NOTICE UNDER SCHEDULE VI CHAPTER XI, RULE 2 (I) OF
THE CITY OF KARACHI MUNICIPAL ACT 1933.

Pursuant to the provision of Schedule VI, Chapter XI, Rule (1) of the City of Karachi Municipal Act 1933, I hereby give you notice that I intend with the meaning of that rule to erect a building on plot No. 127 Survey Sheet S.R. 5 Situated in Narain street Serai Quarter as per Ground plan, Elevation and Section sent herewith in quadruplicate,

No. B. S. P. 673/34

Case No. P/C 673/34.

—AMENDED PLAN—

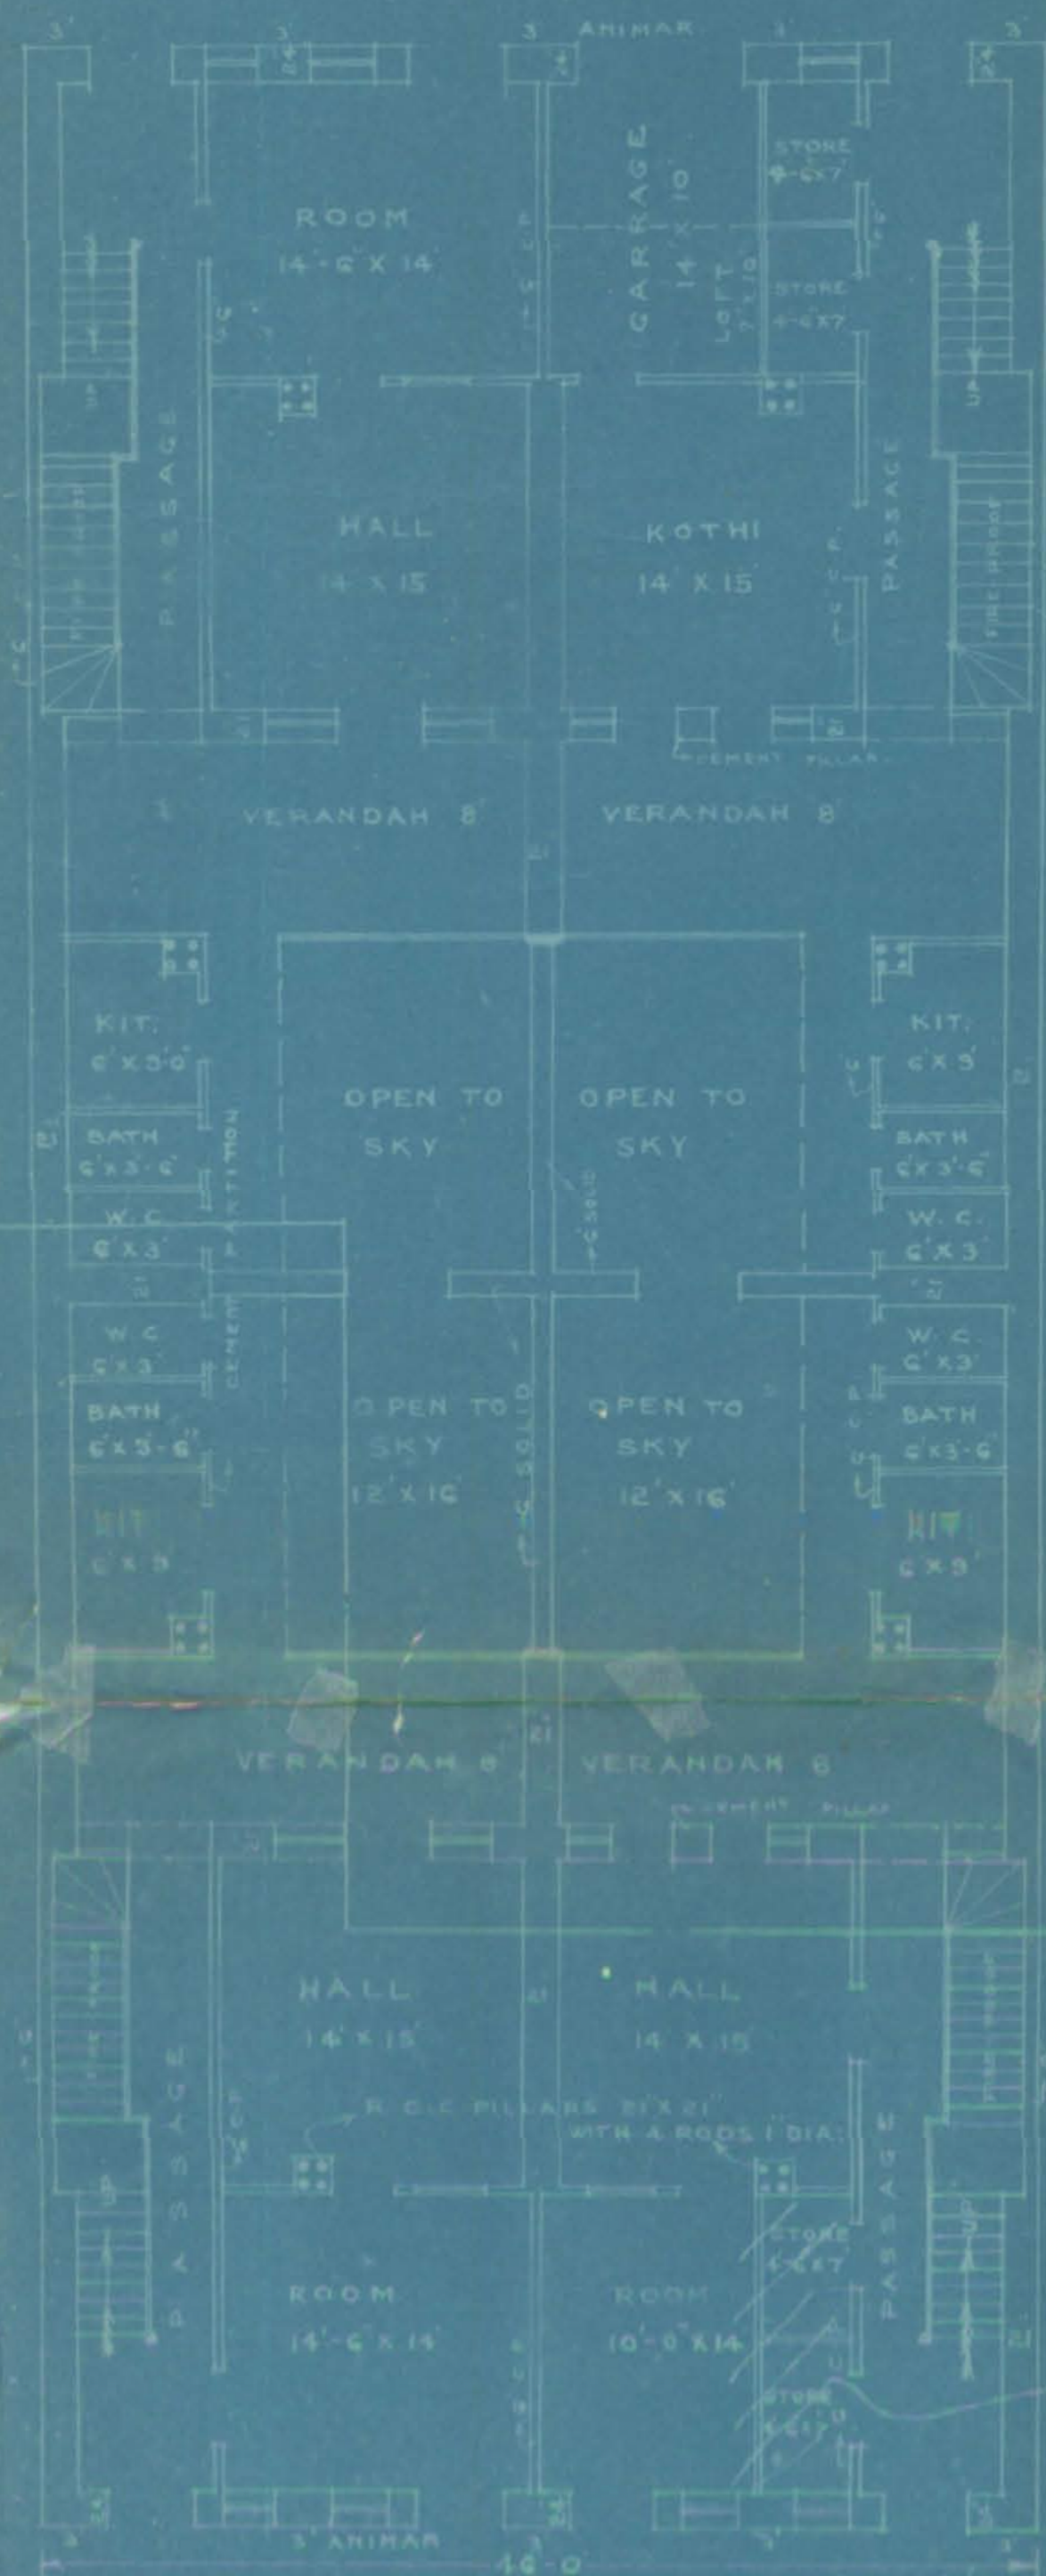
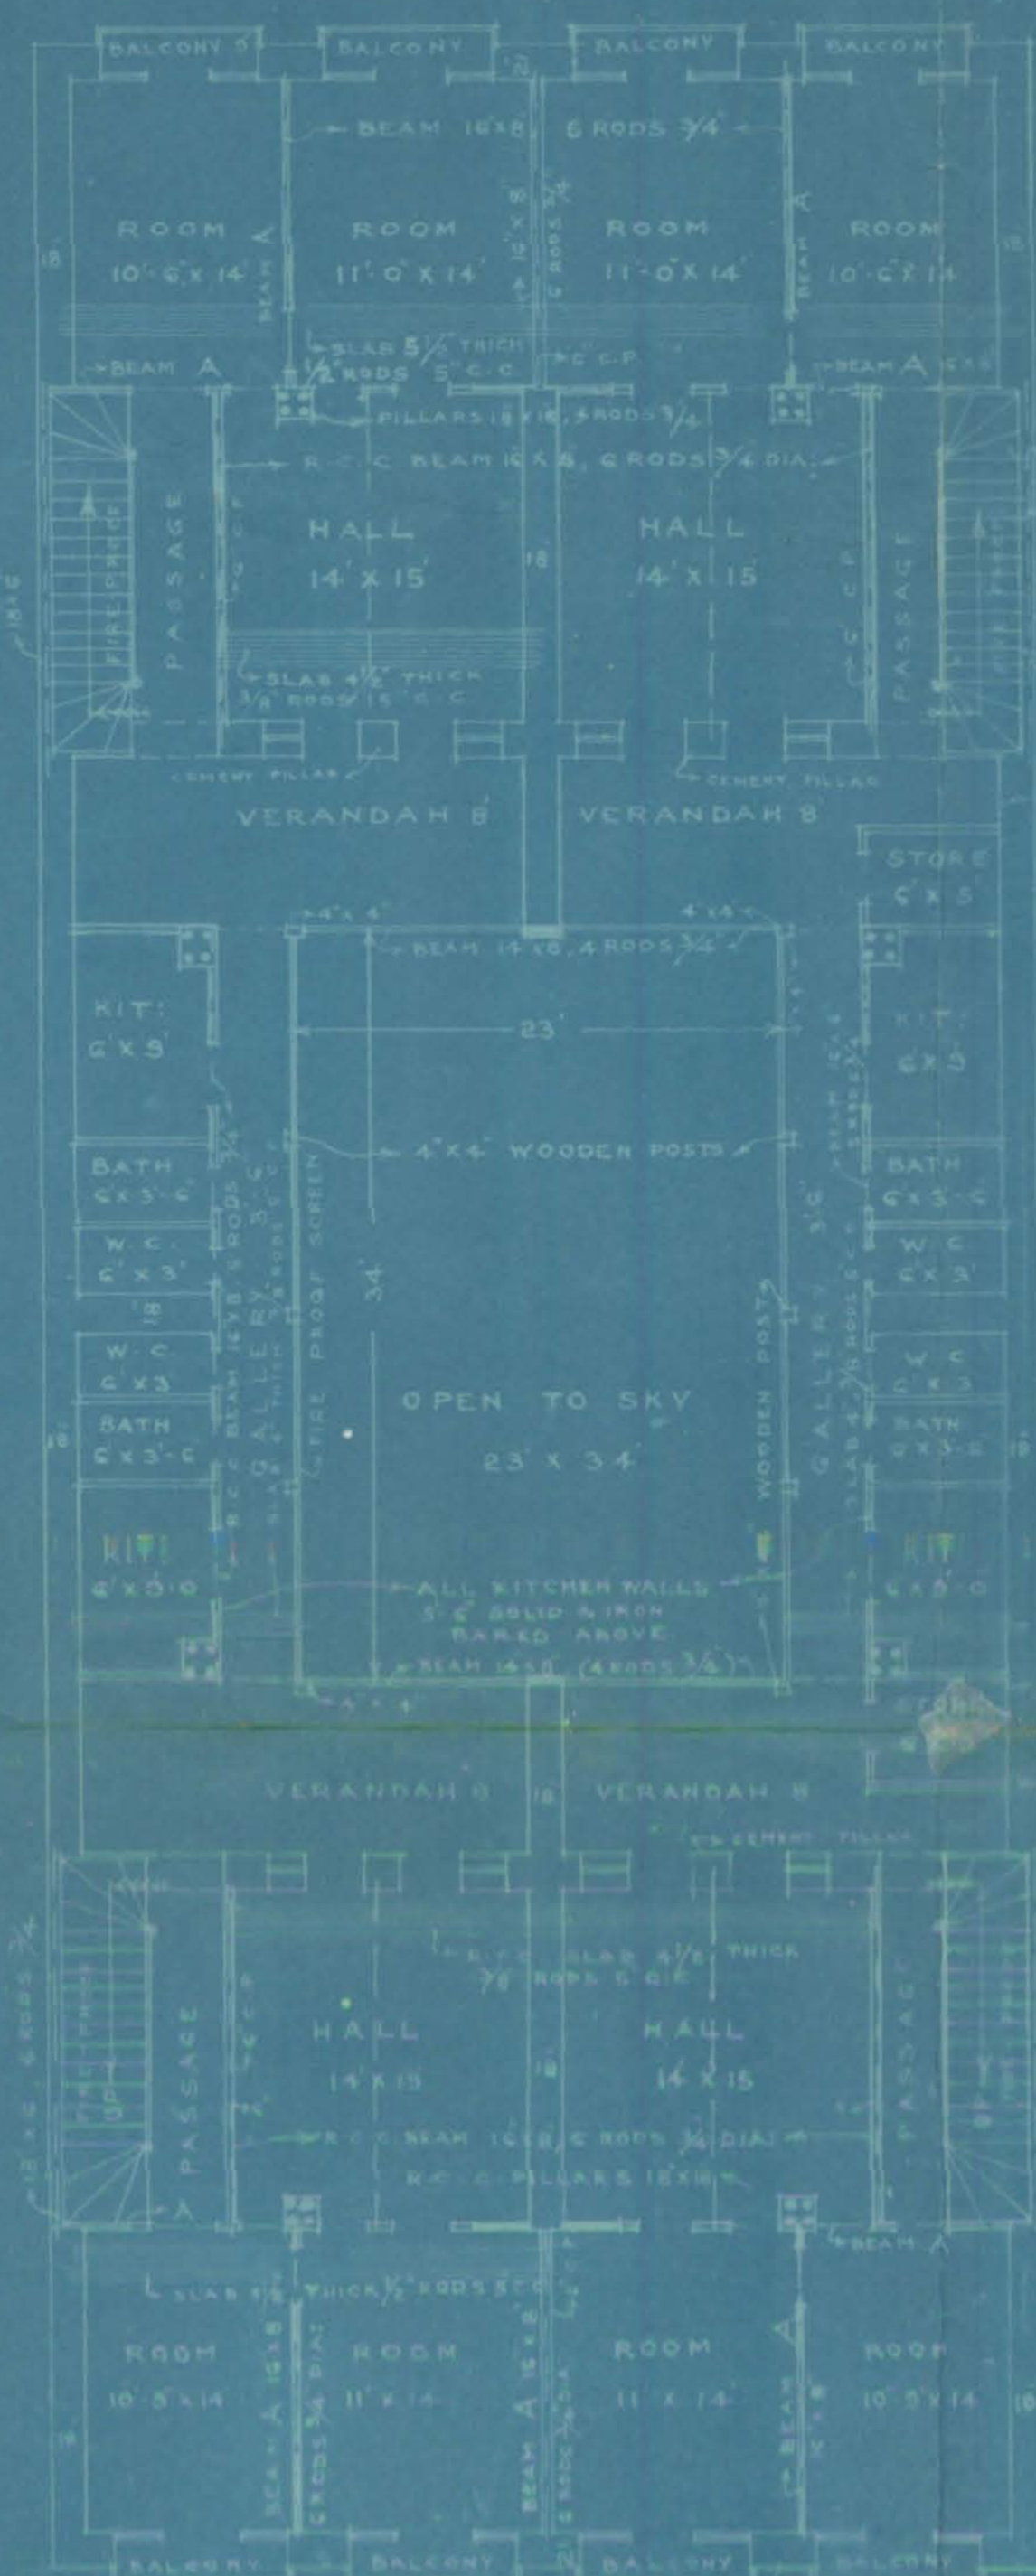
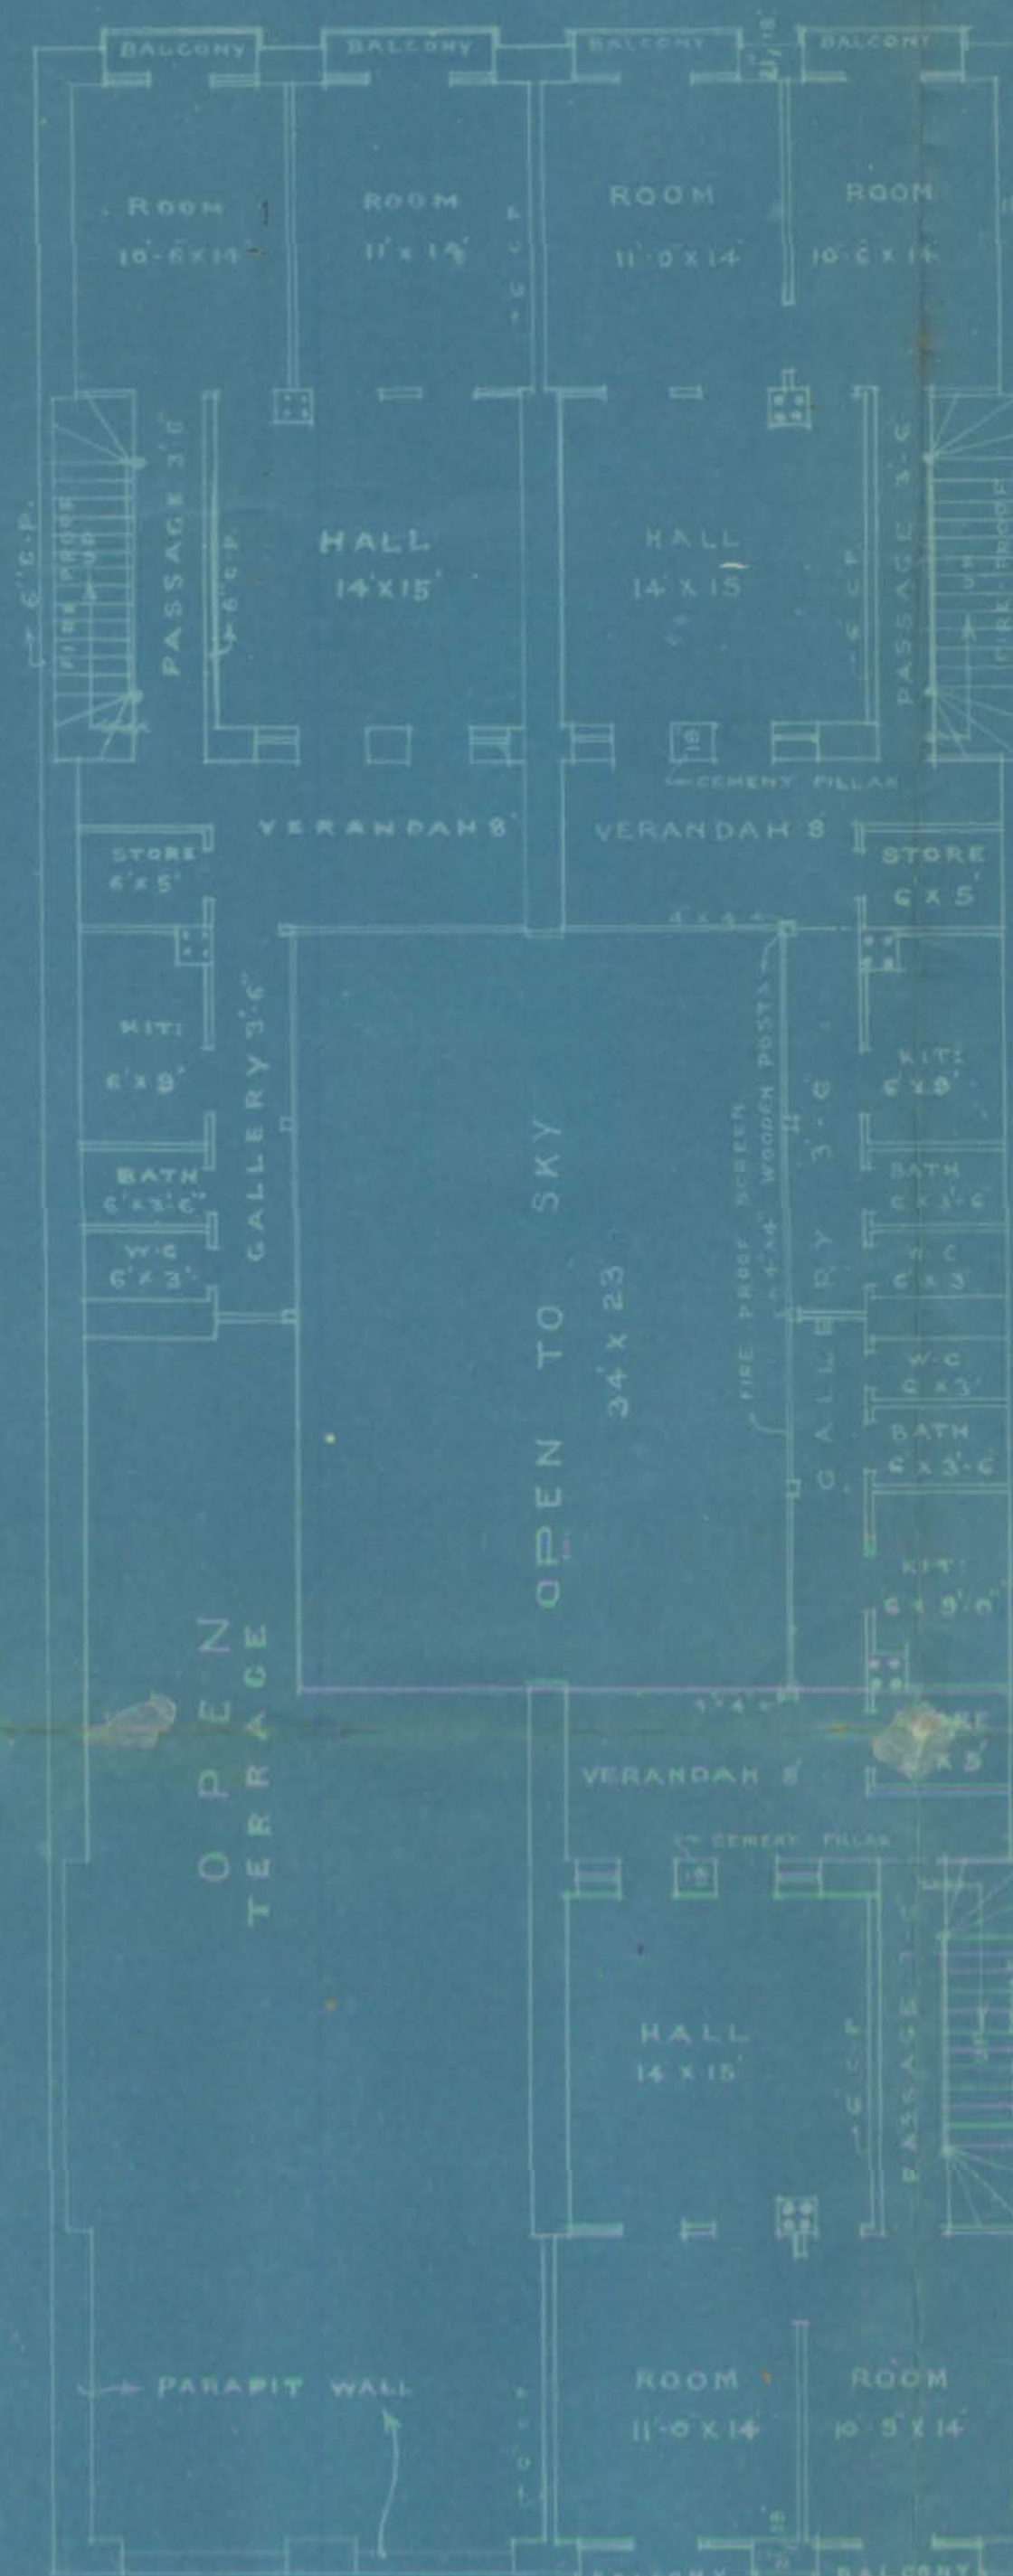
1. Plot no. as per subdivision must be given on the plan.
2. Measurements of dickies must be given.

(2) Plot Numbers are not correctly
shown as per sanctioned sub-division

Plot No. as per
sanctioned sub division
map shown
correctly
25/1

(1) Dicky measurements
are shown by the architect
